Technical Service Bulletin (TSB)
RSU With Additional Sleep Cycles for HV Battery Integrity Check
- Flash: Battery Pack Control Module (BPCM) Updates 11A1

REFERENCE:	TSB: 08-076-25 REV. A GROUP: 08 - Electrical	Date:	April 25, 2025	REVISION:	08-076-25
VEHICLES AFFECTED:	2024 (KM) Jeep Wagoneer S This bulletin applies to vehicles equipped with 400V G2500 FR/RR Elec Drive Motors (Sales Code ELD).			MARKET APPLICABILITY: <input checked="" type="checkbox"/> NA <input checked="" type="checkbox"/> **IAP** <input checked="" type="checkbox"/> **SA** <input checked="" type="checkbox"/> **CH** <input checked="" type="checkbox"/> **EE** <input checked="" type="checkbox"/> **MEA** **	
CUSTOMER SYMPTOM:	<p>Customers may experience a Malfunction Indicator Lamp (MIL) illumination and the vehicle may exhibit/set one or more of the following Diagnostic Trouble Codes (DTCs):</p> <ul style="list-style-type: none"> ● **P0DE6 - Hybrid/EV Battery Pack Cell Voltage Low. <p>NOTE: Active or stored.</p> <ul style="list-style-type: none"> ● P1DAF - Incompatible Limp In Action Requested. <p>NOTE: Active or stored.</p> <ul style="list-style-type: none"> ● P1CDE – Hybrid/EV Wakeup Control 2 Output Circuit Short

Fig. 1
Cooling Fan Assembly

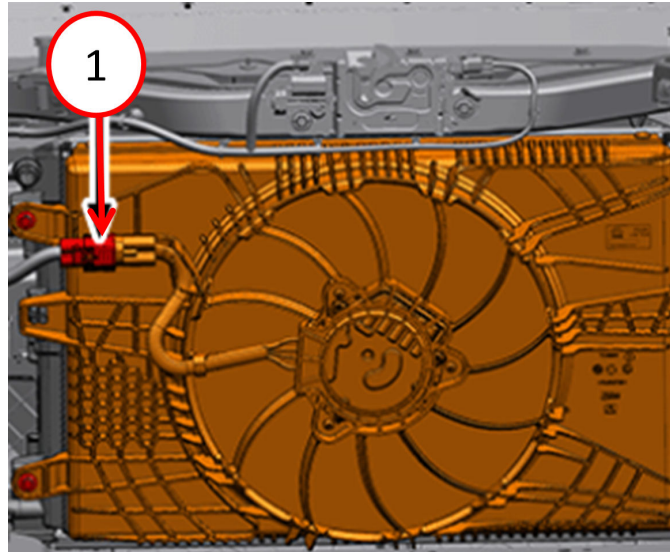
NOTE: The cooling fan must be disconnected to prevent it from powering on, which may interrupt/ abort the flash process.
4. Disconnect the cooling fan wire harness connector [Fig. 1](#).

26. Connect the cooling fan wire harness connector [Fig. 1](#).

Fig. 3
#38 AGSM Fuse Location

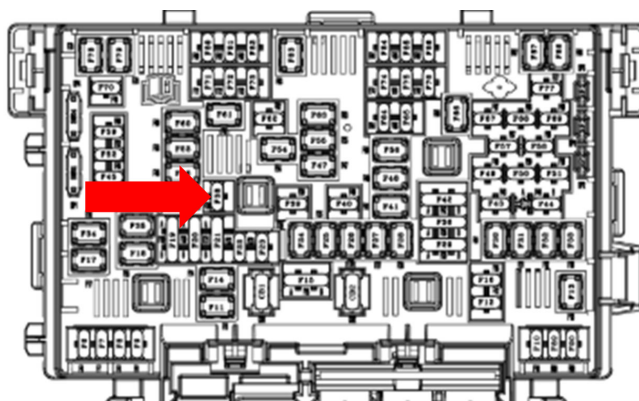
Failure to remove the #38 AGSM fuse will result in damage to the shifter.

6. Remove the PDC cover, locate and remove the #38 AGSM fuse [Fig. 3](#).**

24. **Install the #38 AGSM fuse [Fig. 3](#) and the PDC cover [Fig. 2](#).
